**CONSTRUCTION OF THE HWY 14 SENIOR/COMMUNITY CENTER**

**IFB#2018-0238-PW/IC**

**ADDENDUM No. 1**

SHEET TITLE: SITE PLAN

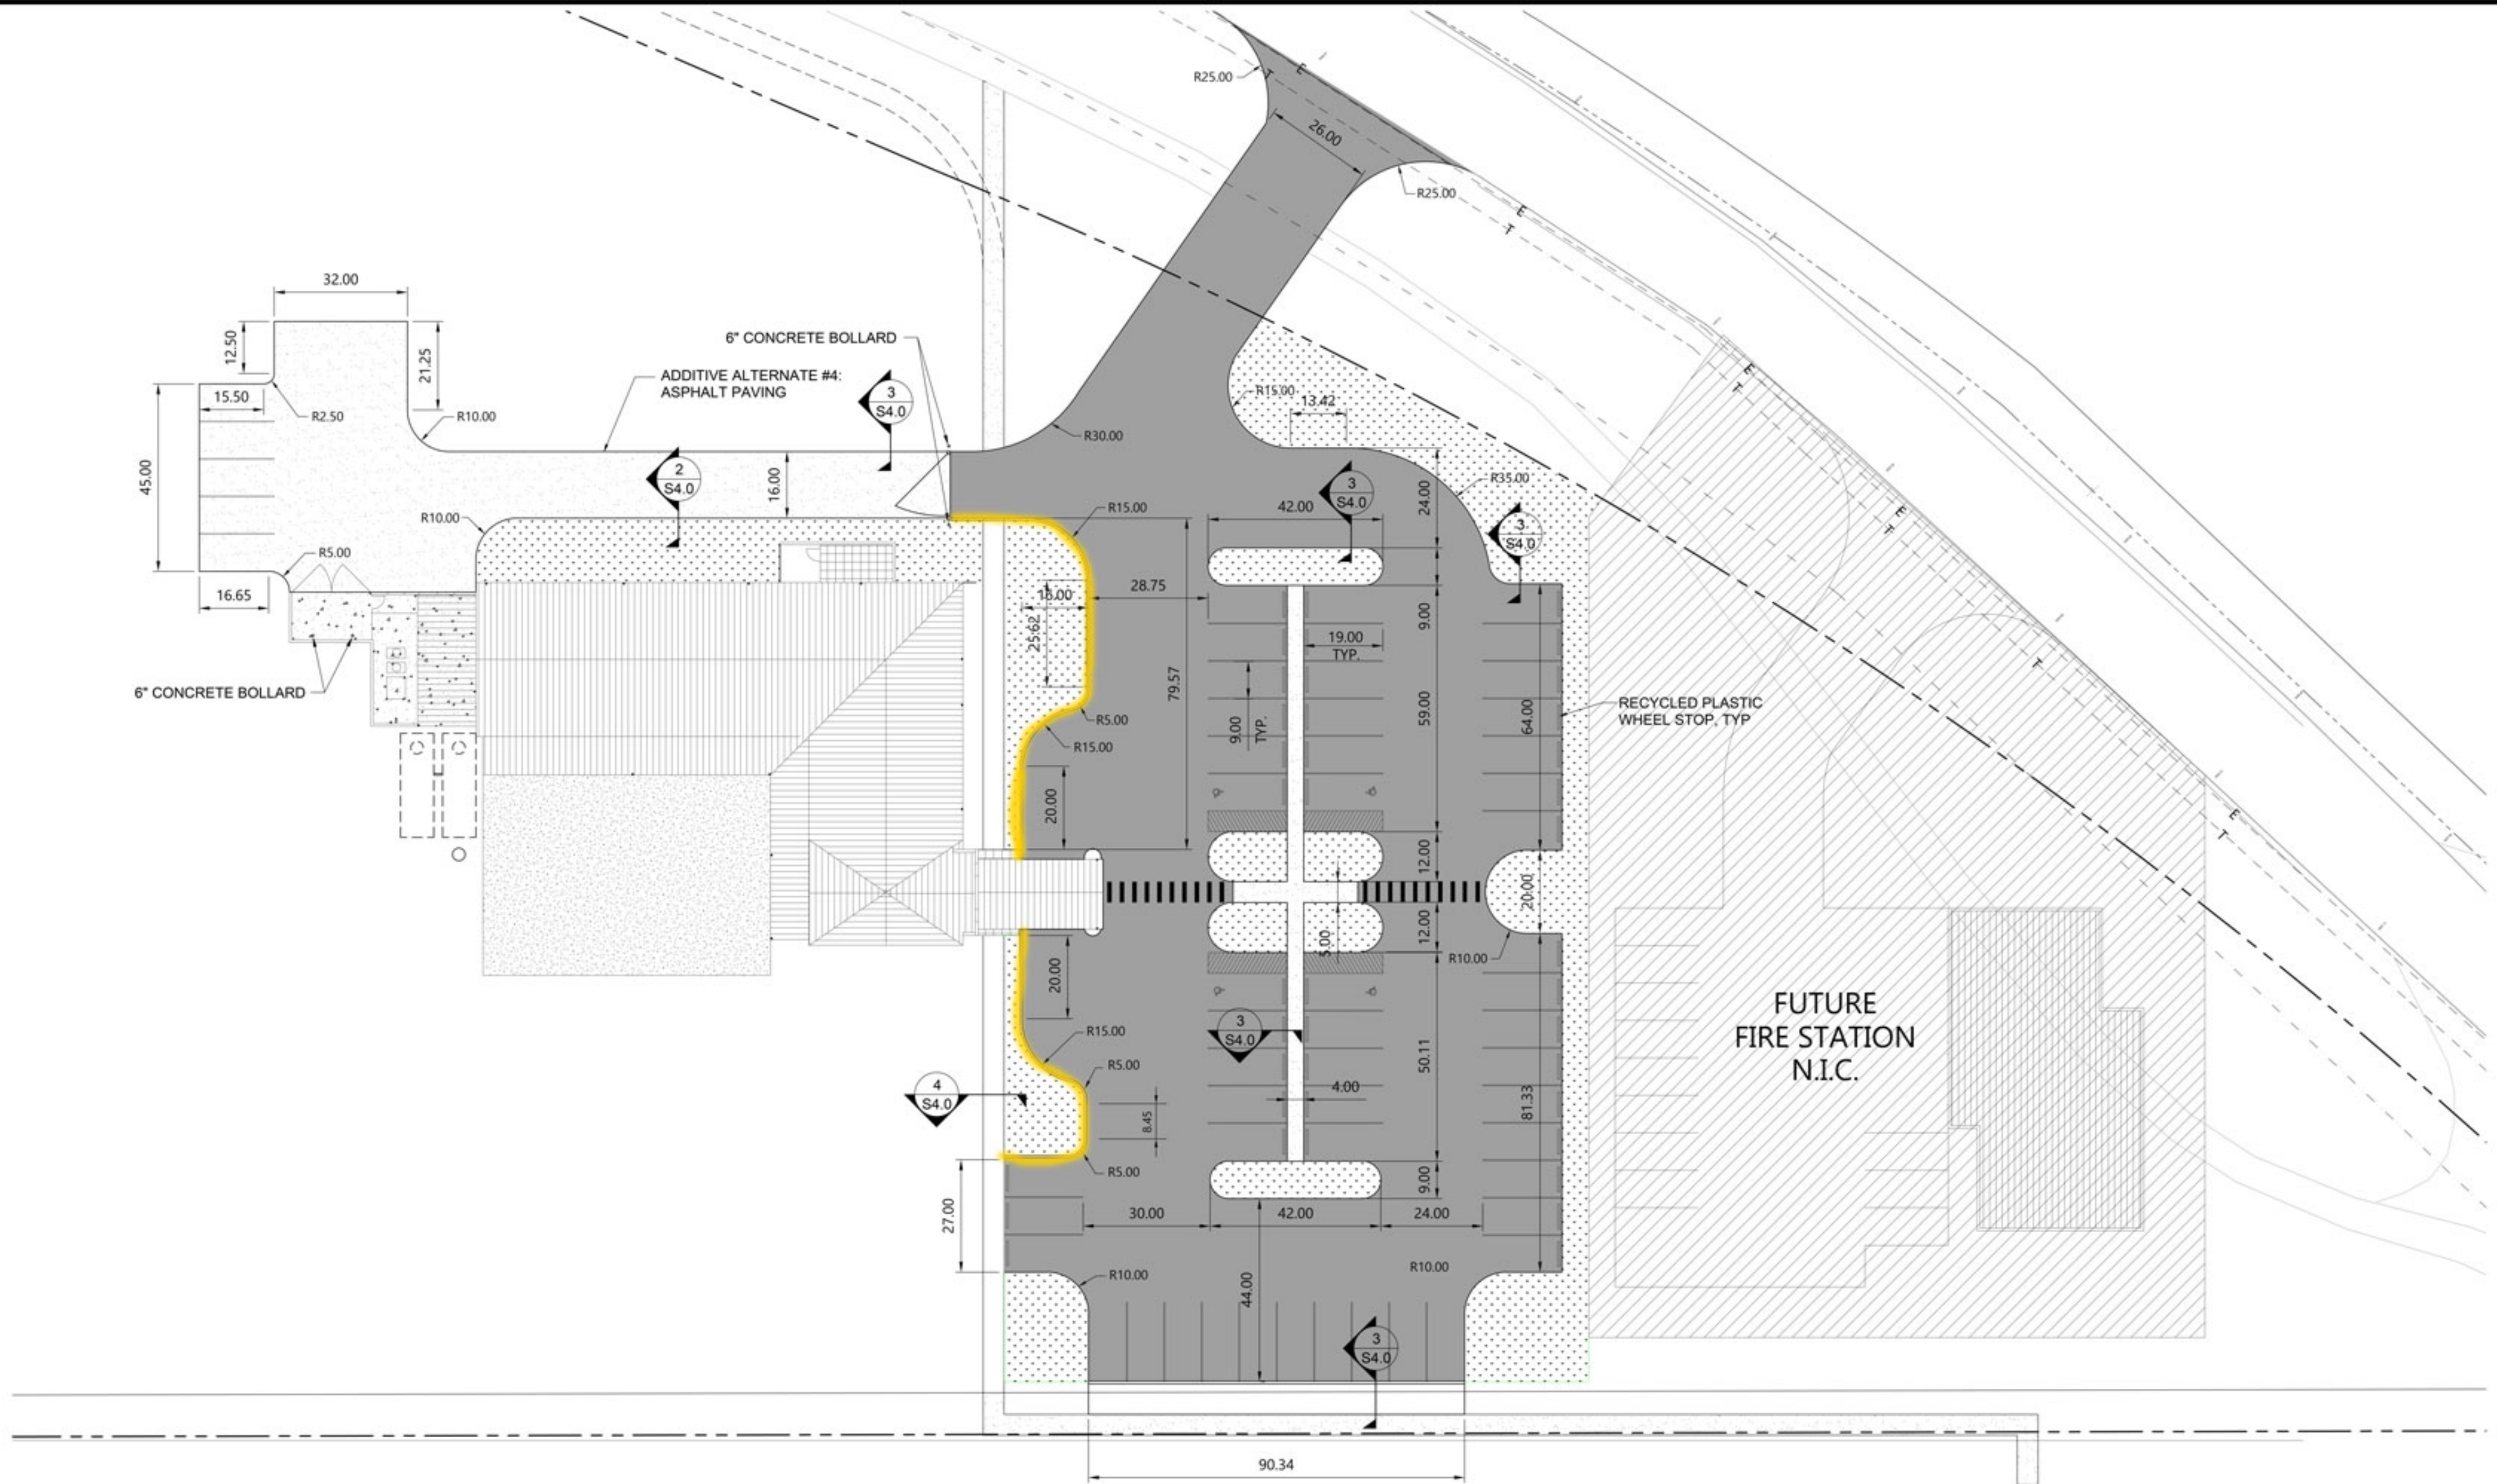
**Question 3:** Sheet C1.0, it is difficult to determine where the different types of curbs start and stop. Please add some detail callouts or depict the curbs differently with line type.

**Response 3:** The only curb that is not a flush curb is along the east frontage of the Senior Center to prevent flooding of the building. It is delineated clearly with a double line as

opposed to everywhere else. See C1.0 Attached. See details on C4.0 for requested details.
